Access Compliance Report

Public Rights-of-Way

(Curb Ramps)

Intersection ID: 23847	Main Street: ARLANDES_DR	Cross Street: ROZIER_DR	Location:	SW
ADA ID: 5072717A2D79	Ramp Type: PerpDiag	Initial Pass/Fail: Pass	Overall Compliance: No	Severity Score: 10
Codes/Mitigation Info/Possible Solution		Field Measurements/Component Compliance

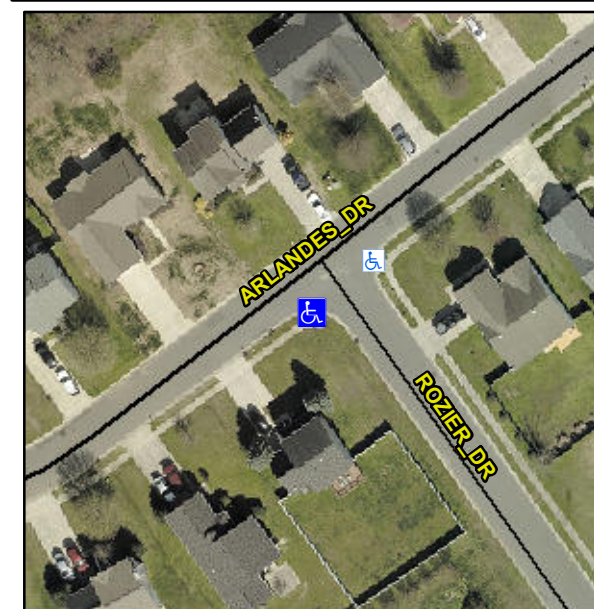
R304.2.1, R304.2.2-Perp, R304.3.2-Para, R304.5.3, R305

Compliance	Description	Data	Compliance	Description	Data
N/A	Ramp Length (in)	47.0	Yes	Ramp Slope (%)	7.0
Yes	Ramp Width (in)	97.0	Yes	Ramp XSlope (%)	0.7
N/A	Flare Type LT	Sloped	N/A	Flare Type RT	N/A
N/A	Flare Slope LT (%)	10.1	N/A	Flare Slope RT (%)	2.7
N/A	Flare Traversable LT?	No	N/A	Flare Traversable RT?	No
No	Landing Length (in)	47.5	No	DWS Provided?	No
Yes	Landing Width (in)	97.5	N/A	DWS Contrast?	No
No	Landing Slope (%)	2.2	N/A	DWS Length (in)	N/A
No	Landing X Slope (%)	4.4	N/A	DWS Full Width?	No
N/A	Landing Curb? (Y/N)	No	N/A	DWS Offset (in)	N/A
N/A	Shared Landing?	No			
Yes	Gutter Ponding?	No	Yes	Gutter Slope (%)	0.8
Yes	Gutter Lip Ht (in)	0.0	No	Gutter X Slope (%)	3.3
N/A	Painted X Walk1?	No	N/A	Painted X Walk2?	No
	X Walk 1 Direction	To NE		X Walk 2 Direction	To NW
N/A	X Walk 1 Width (in)	N/A	N/A	X Walk 2 Width (in)	N/A
	X Walk 1 Slope (%)	1.9		X Walk 2 Slope (%)	1.8
	X Walk 1 X Slope (%)	0.6		X Walk 2 X Slope (%)	3.3

N/A	Ramp inside XWalk1?	N/A	N/A	Ramp inside XWalk2?	N/A
	Road Slope (%)	3.6	N/A	Clear Space?	Yes
	Road X Slope (%)	1.0	N/A	Clear Space to XWalk (in)	N/A
Yes	Any Obstructions?	No	Yes	Storm Grate/Utility Hazard?	No
	Obstruction Type			Storm Grate/Utility Type	
		N/A			N/A
			Yes	Surface Condition? (G/P)	Good

Remove & Replace Curb Ramp With Two New Directional Ramps or Equivalent. Remove & Replace Gutter.
